Technical Bulletin

New Generation POPIT Missings

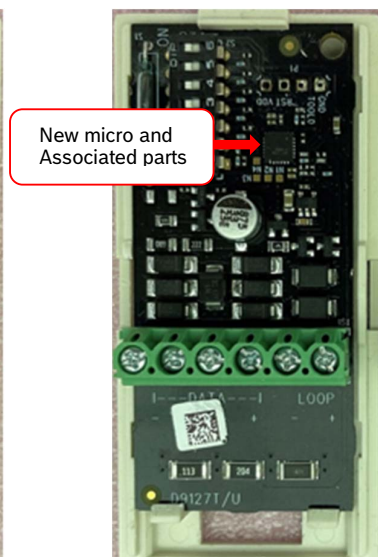
When used on B9512G or B8512G control panels, any changes made from RPS or supporting keypad may result in new generation POPITs connected to a D8125 going *“missing.”*

Points will return on their own (20-30 seconds) but depending on programming, they may need to be cleared or acknowledged.

Bosch will fix this issue in control panel firmware version 3.15.xxx. Expected to release in Q4, 2024.
